ENVIRONMENTAL ASSESSMENT

* KALAKAUA CENTER *

TAX MAP KEY: 2-6-14: 01, 04, 6-8, 19-20 & 58

ADDENDUM TO ENVIRONMENTAL ASSESSMENT (EA): KALAKAUA CENTER

KALAKAUA CENTER
 PROPOSED SEWER
 SYSTEM ALTERNATIVES
 ALTERNATE-A

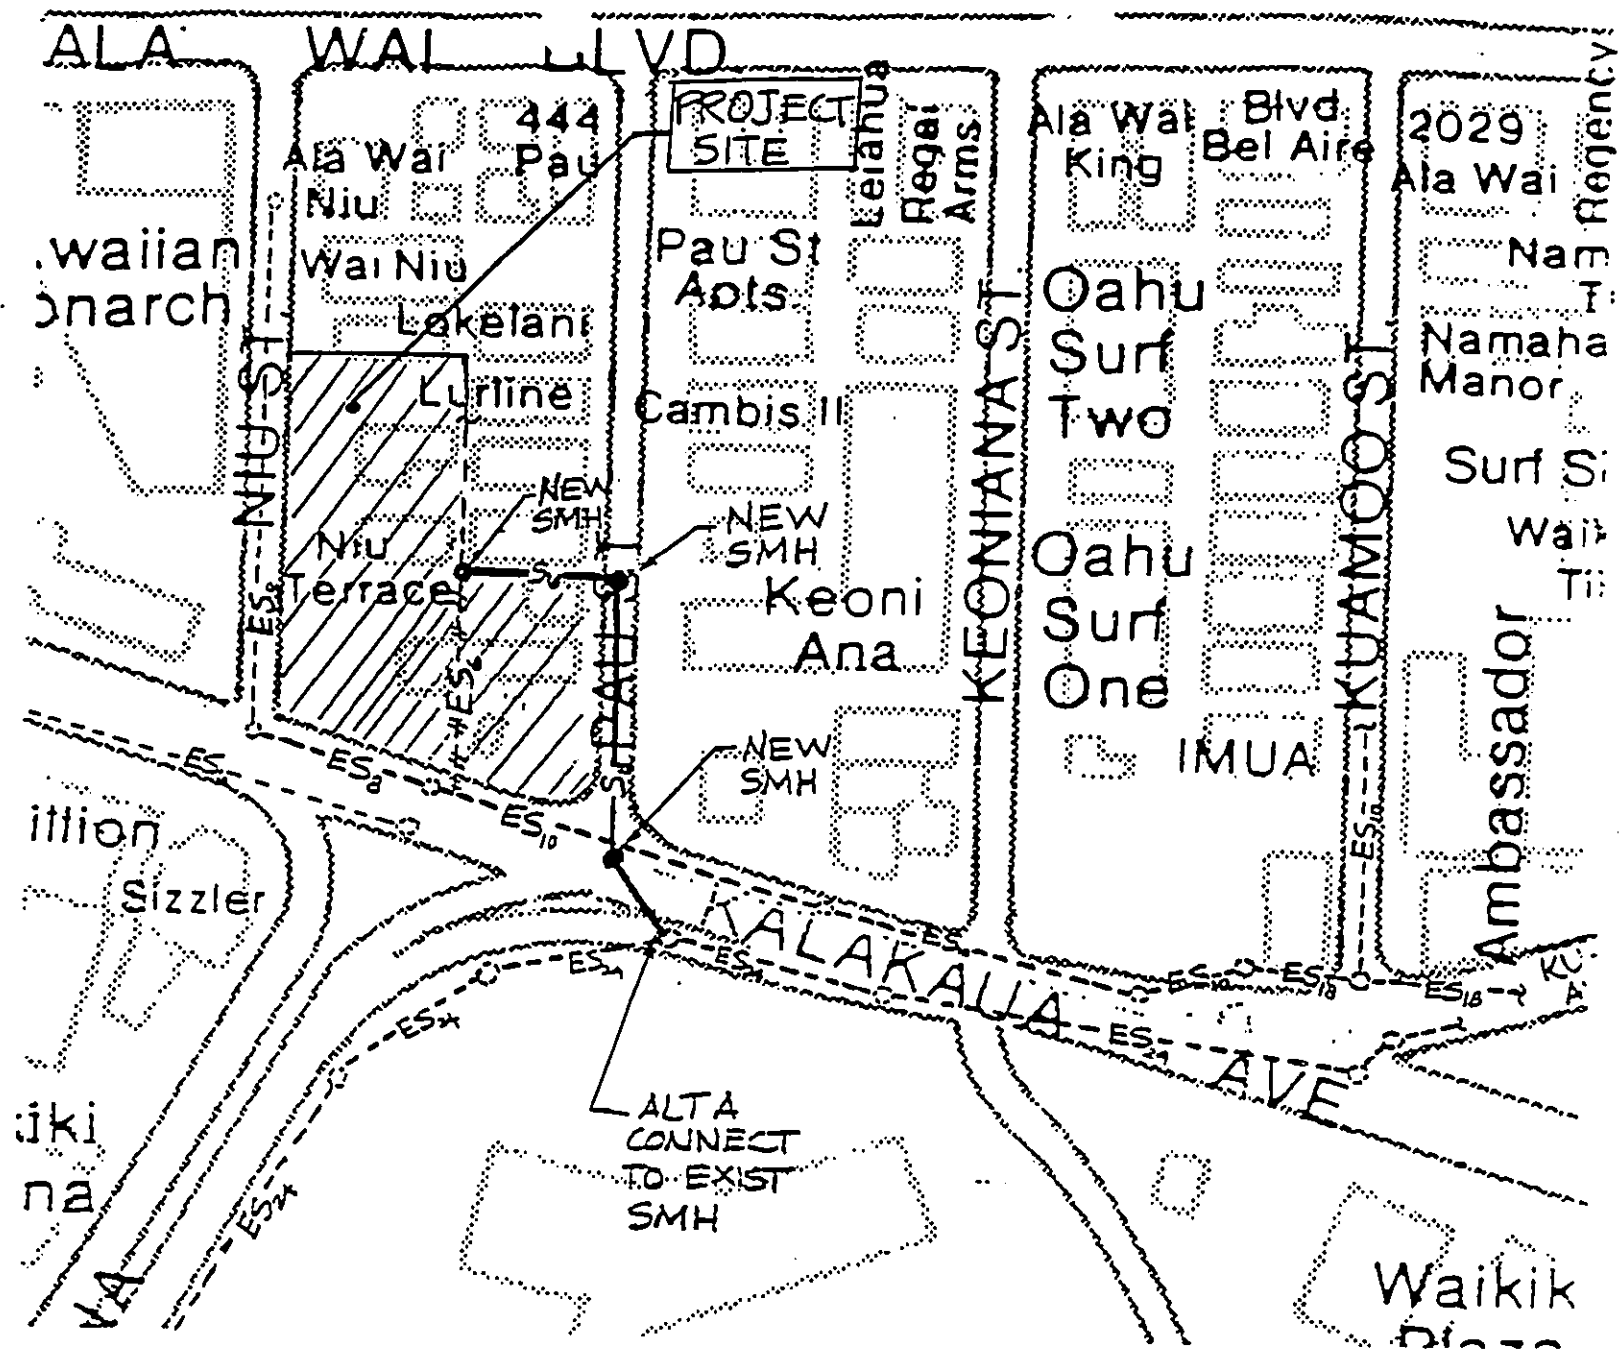
Comments: "The existing 10-inch sewer line on Kalakaua Avenue between Niu Street and Kuamoo Street is inadequate to accommodate the proposed center. The Negative Declaration for this project should address how this proposed development will be sewerred. We understand that all roadway widenings and Ordinance No. 2412 requirements will be met by the applicant."

Response: By letter dated April 23, 1991, Hida, Okamoto & Associates, Inc., Consulting Engineers for the project, proposed two alternatives with regard to sewer improvements (copy attached). By letter dated May 1, 1991, DPW responded that one of these, Alternate B, was an acceptable solution (copy attached). Alternate B calls for extending an 8-inch sewerline parallel to the existing 10-inch sewer on the Mauka side of Kalakaua Avenue and reconnecting to an existing SMH near Kuamoo St. and Kuhio Avenue (refer to Exhibit C of Hida, Okamoto & Associates letter). In addition, the applicant will meet all roadway widenings and Ordinance No. 2412 requirements.

Your Alternate B proposal is the only acceptable solution. Should you decide to pursue this alternative, please resubmit a new "Sewer Connection" application reflecting the Alternate B relief. In addition, construction plans of the relief sewer lines shall be submitted to my office for review and approval.
